Access Compliance Report

Public Rights-of-Way

Intersection ID: 30581	Main Street: CIRCLEGREEN_DR	Cross Street: N/A	Location: NW
ADA ID: FBF31204C6EE	Ramp Type: PerpDiag	Initial Pass/Fail: Fail	Overall Compliance: No
Severity Score: 25			
Codes/Mitigation Info/Possible Solution		Field Measurements/Component Compliance

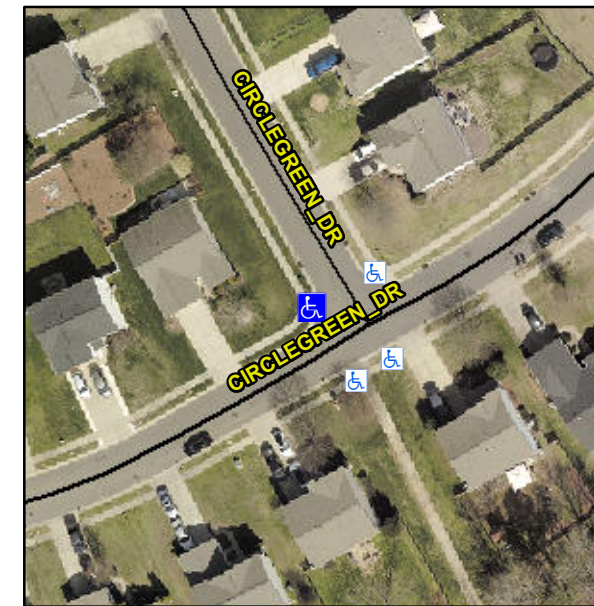
R304.5.3

Remove & Replace Curb Ramp With Two New Directional Ramps or Equivalent.
